GEQUOYAH NUCLEAR PLANT (SQN) UNITS 1 AND 2, AND WATTS BAR  
NUCLEAR PLANT (WBN) UNIT 1, RESPONSE TO NUCLEAR REGULATORY  
COMMISSION (NRC) REQUEST FOR ADDITIONAL INFORMATION REGARDING  
RESPONSE TO NRC GENERIC LETTER (GL) 96-06, "ASSURANCE OF  
EQUIPMENT OPERABILITY AND CONTAINMENT INTEGRITY DURING DESIGN  
BASIS ACCIDENTS" (TAC NOS. M96866, M96867, AND M96884)

TENNESSEE VALLEY AUTHORITY  
SEQUOYAH NUCLEAR PLANT (SQN)  
UNITS 1 AND 2

TENNESSEE VALLEY AUTHORITY  
WATTS BAR NUCLEAR PLANT (WBN)  
UNIT 1

FIGURE 9.2.2-3  
ESSENTIAL RAW COOLING WATER  
(REVISED BY AMENDMENT 13)

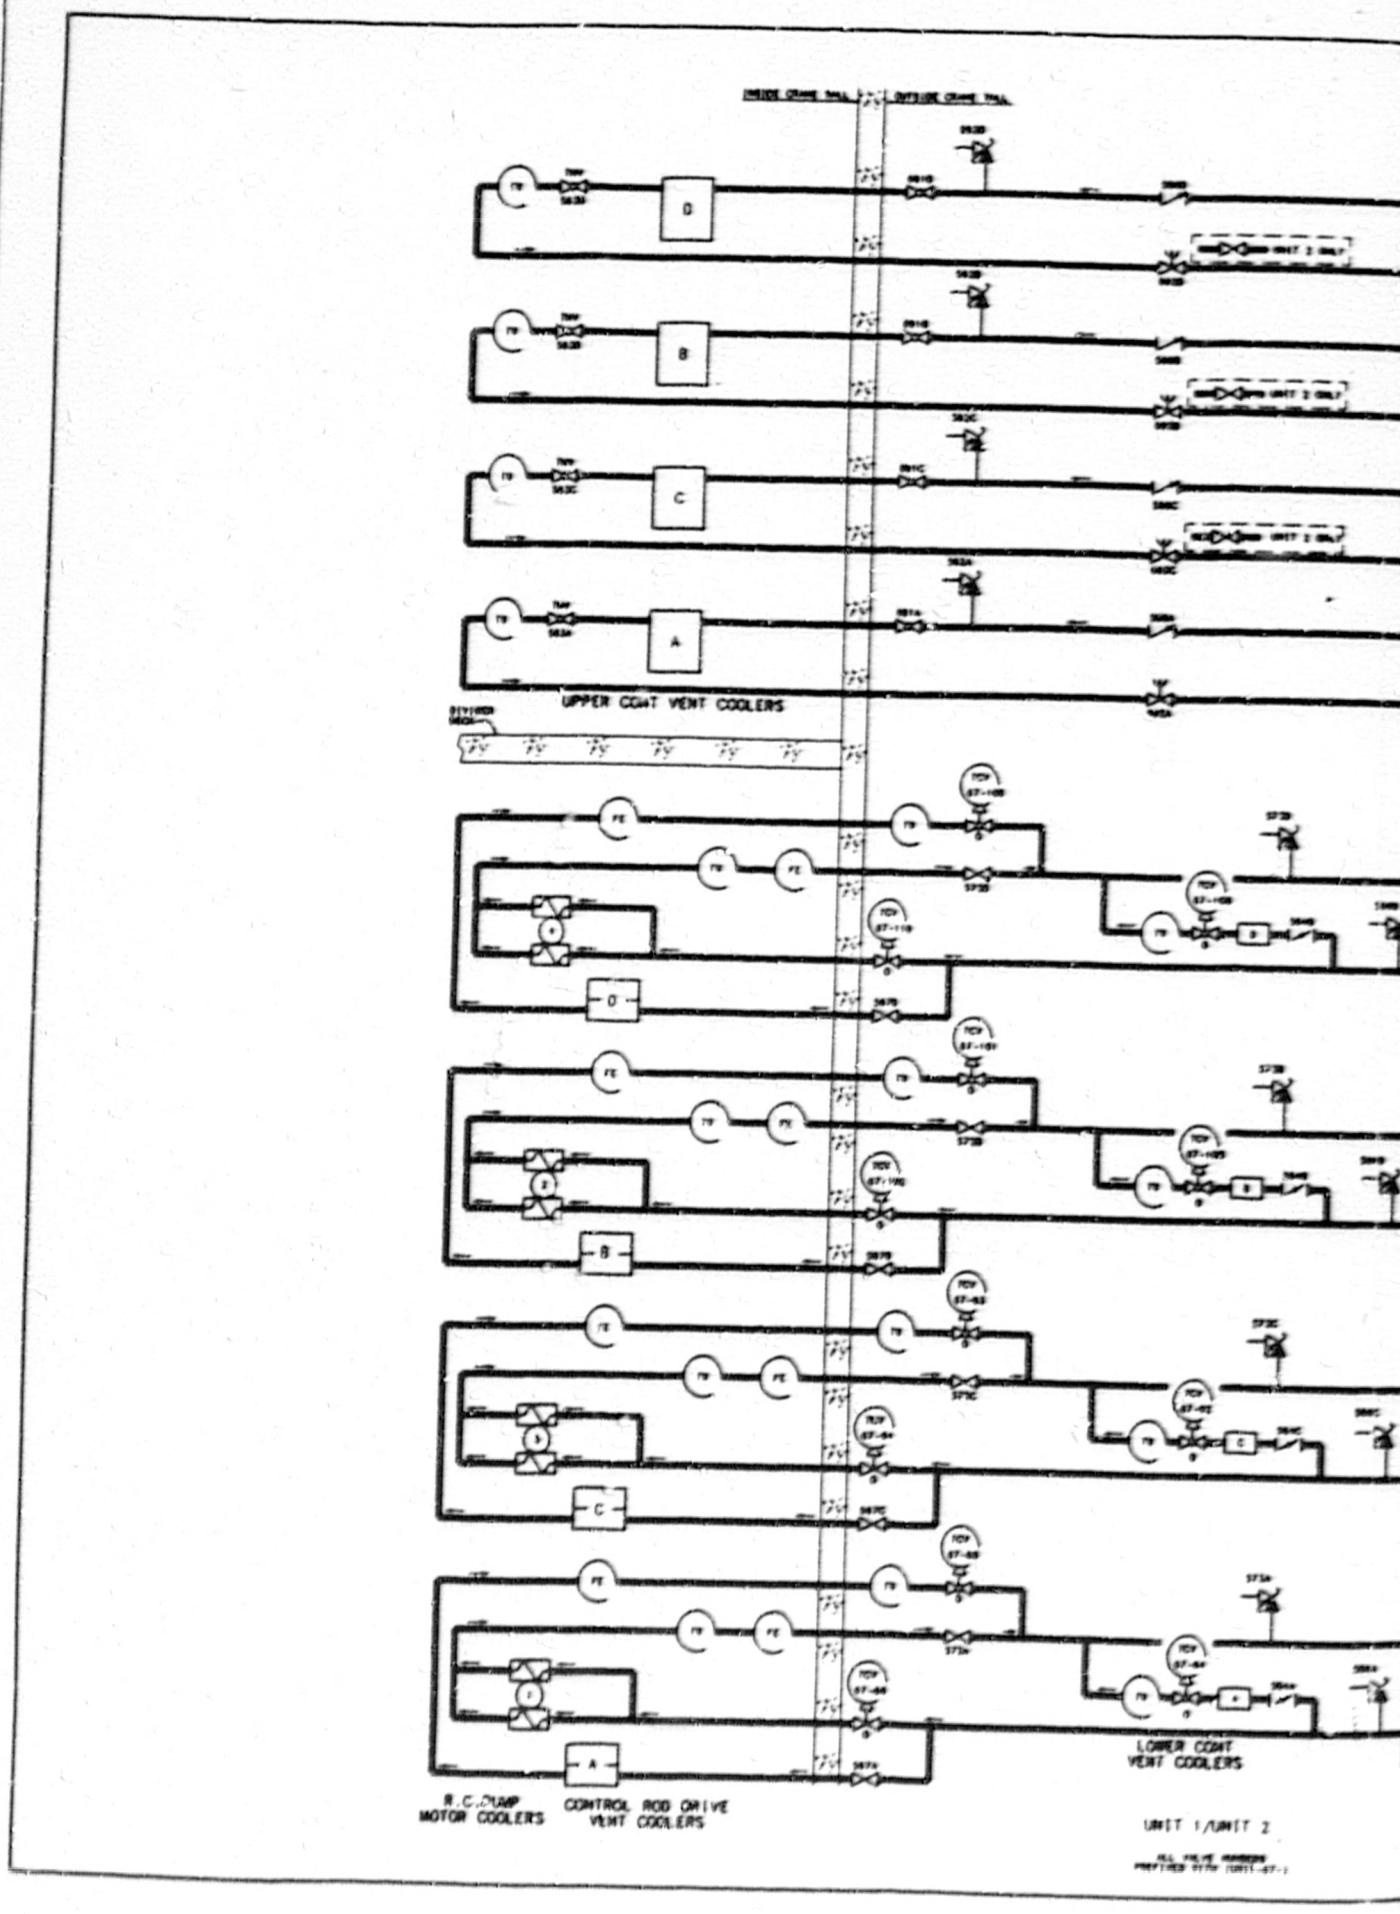
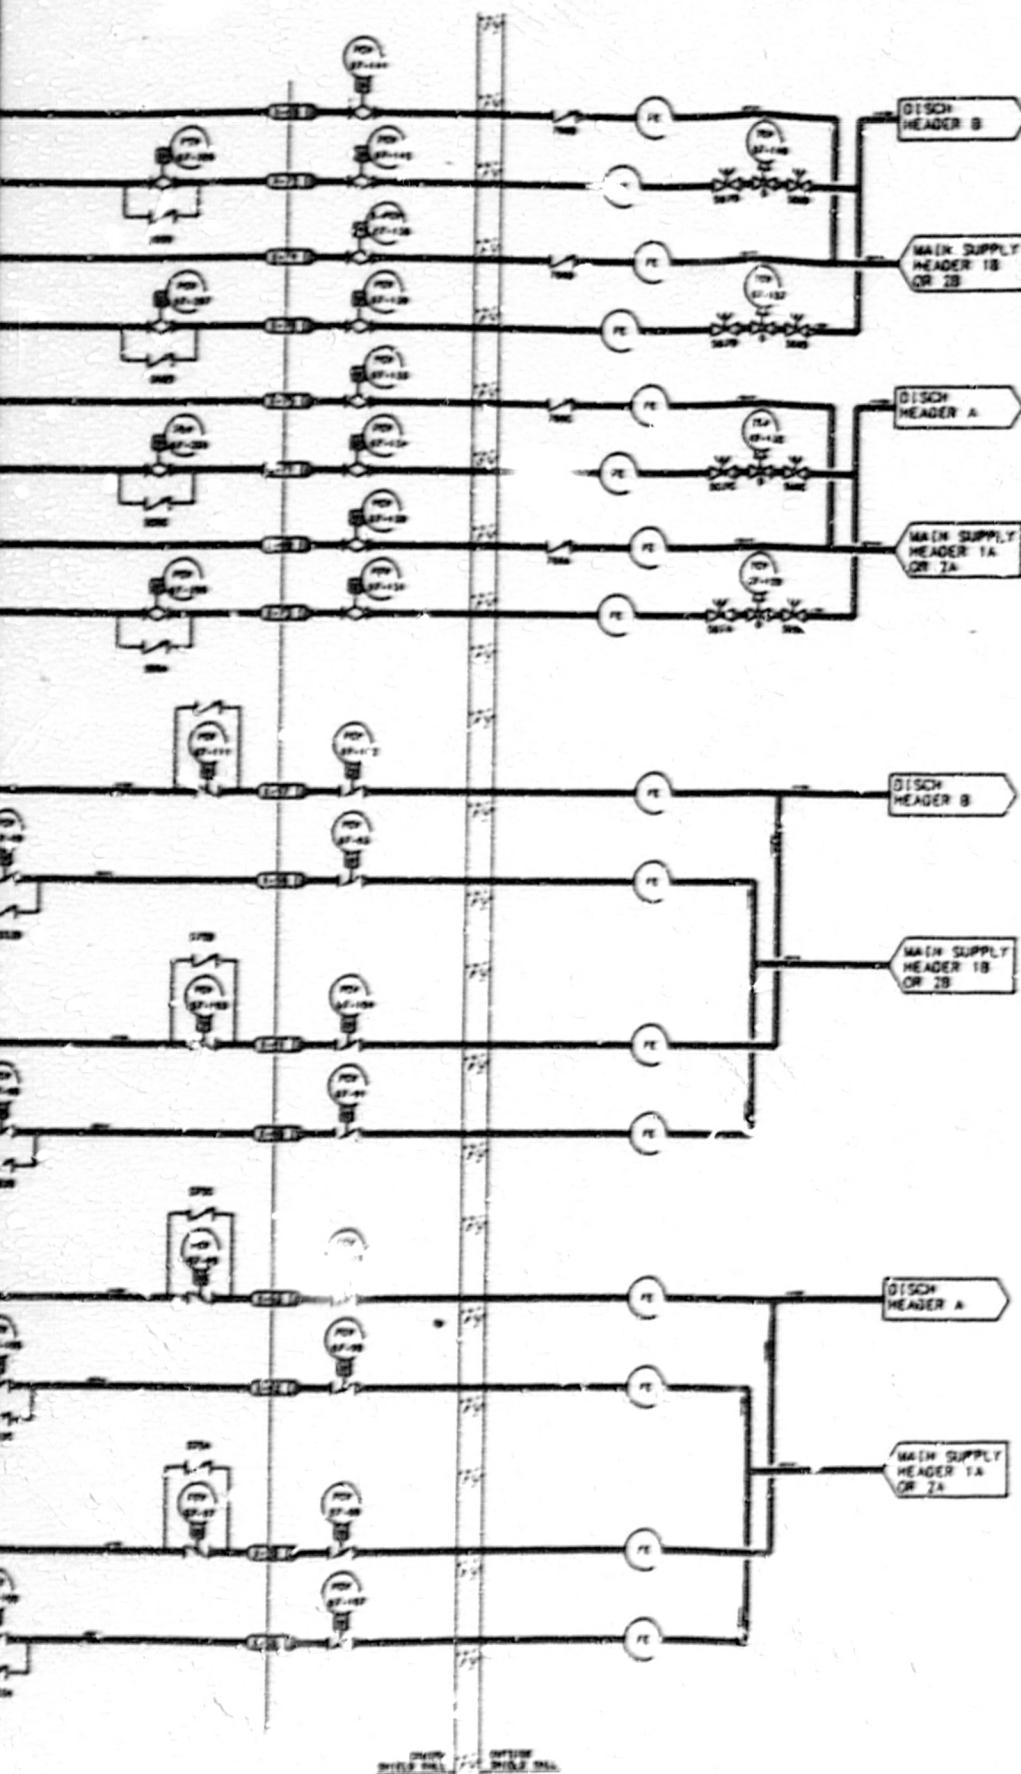
Provide a simplified diagram of the affected systems, showing major components, active components, relative elevations, lengths of piping runs, and the location of any orifices and flow restrictions.

A simplified diagram of relative elevations and lengths of piping runs was not provided since SQN does not have the potential for waterhammer or two-phase flow in any safety-related coolers, and no analysis of waterhammer effects was performed. The flow diagram for ERCW shows the major components, active components, and any orifices and flow restrictions for the ERCW system inside containment. This flow diagram is available to the NRC as UFSAR Figure 9.2.2-3 (copy attached to this enclosure).

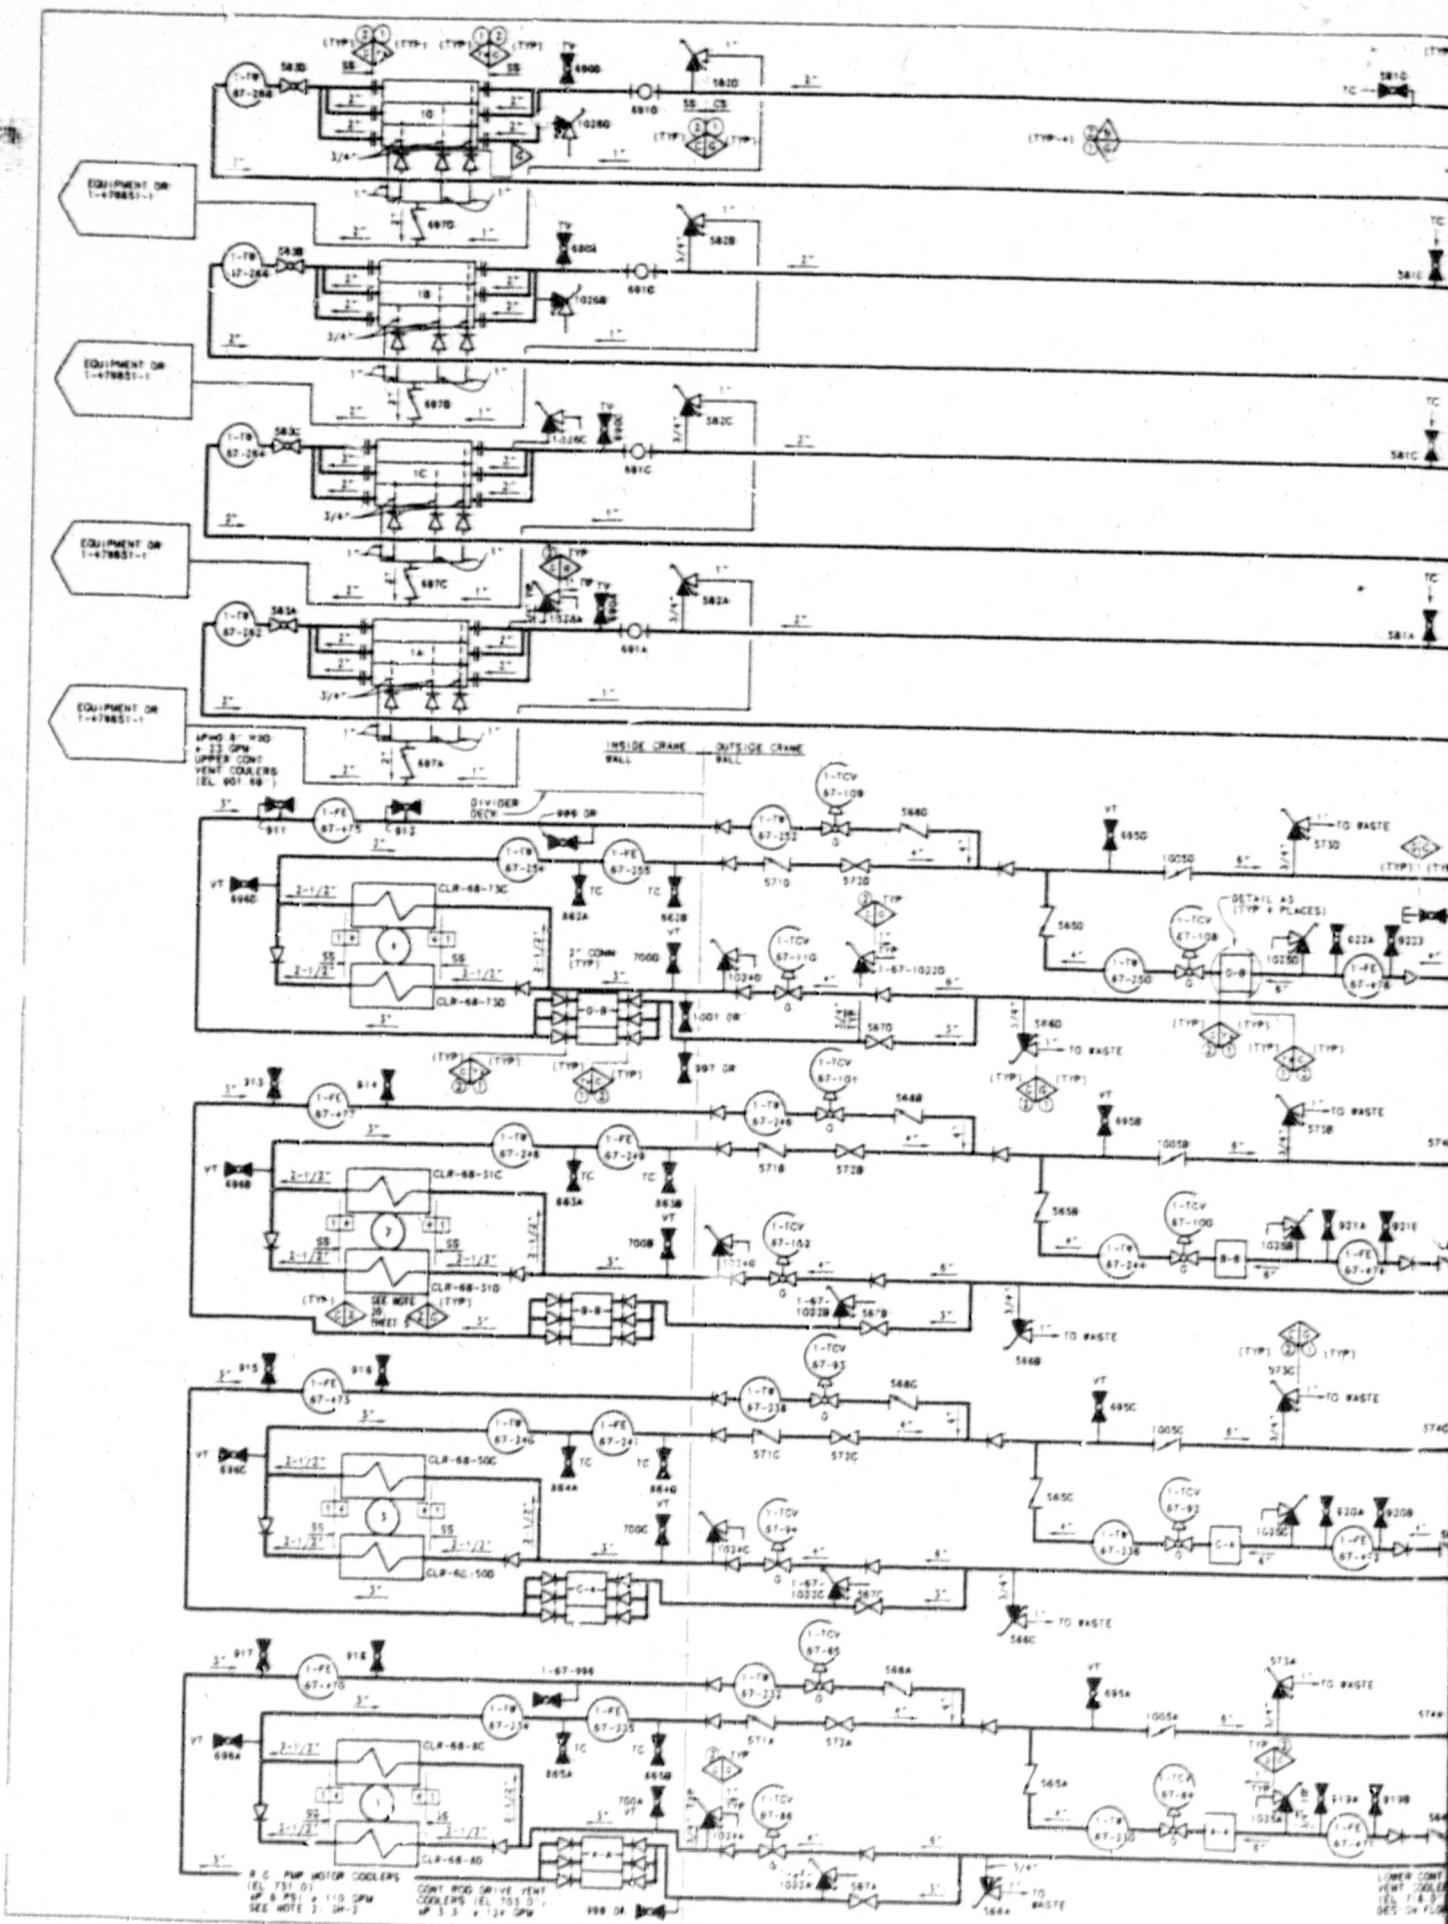
Provide a simplified diagram of the affected systems, showing major components, active components, relative elevations, lengths of piping runs, and the location of any orifices and flow restrictions.

A simplified diagram of relative elevations and lengths of piping runs was not provided since WBN does not have the potential for waterhammer or two-phase flow in any safety-related coolers, and no analysis of waterhammer effects was performed. The flow diagram for ERCW shows the major components, active components, and any orifices and flow restrictions for the ERCW system inside containment. This flow diagram is available to the NRC as FSAR Figure 9.2-3 (copy attached to this enclosure).
